MVP Variance Request Form

No.: B-17

**Mountain Valley Pipeline, LLC
Mountain Valley Pipeline Project
Docket No. CP16-10-000**

**Mountain Valley Pipeline Project
Variance B-17
January 8, 2019**

Mountain Valley Pipeline Project		 NAD 1983 UTM 17N 1 inch = 100 feet	 0 50 100 200 Feet
 Proposed Variance B-17 <i>Lewis County, West Virginia</i> January 2019	Legend  Proposed Variance Limit of Disturbance  Issued for Construction LOD

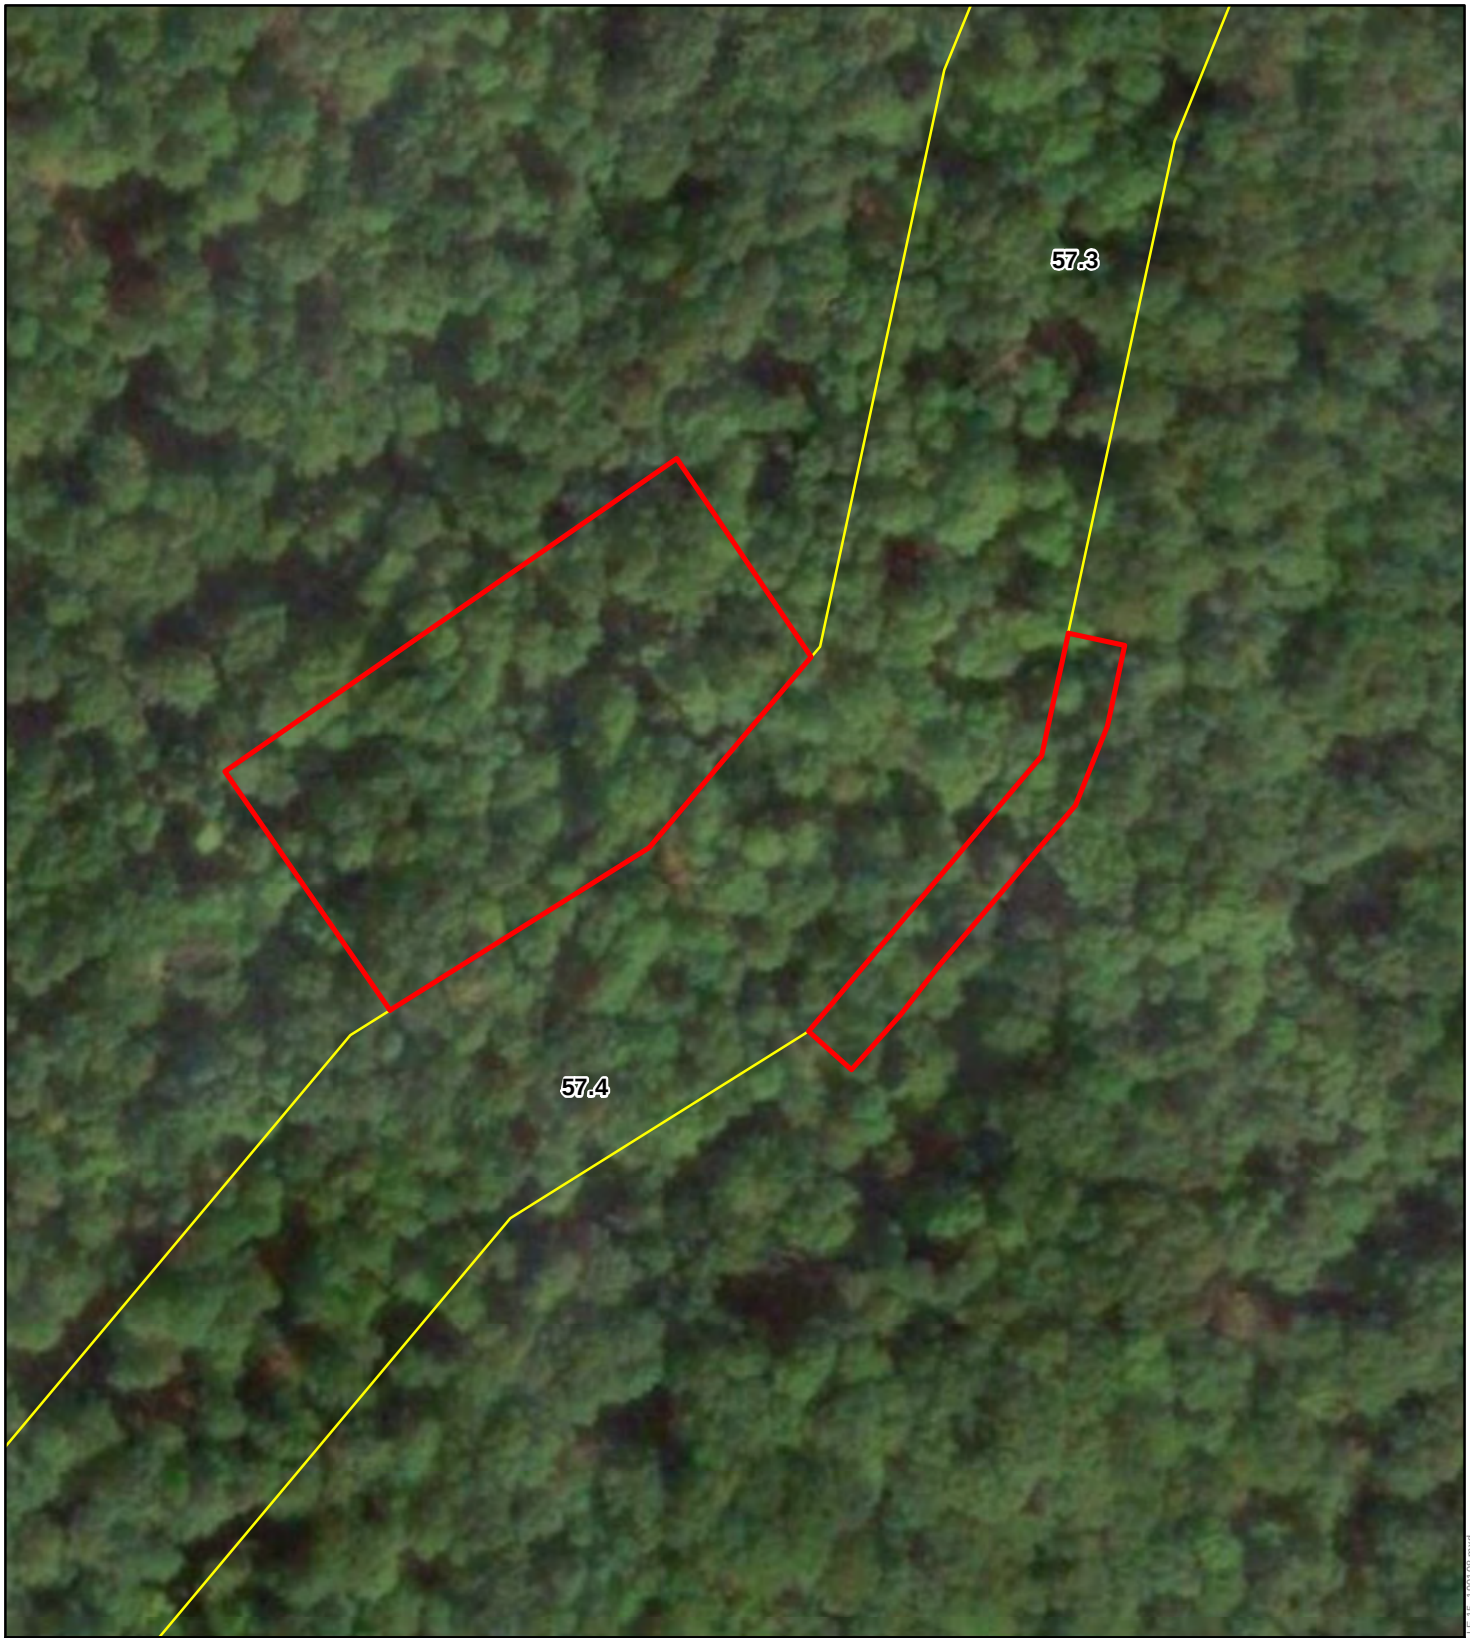
During field surveys, Tetra Tech did not identify any streams or wetlands in the variance area as shown on the attached figure.
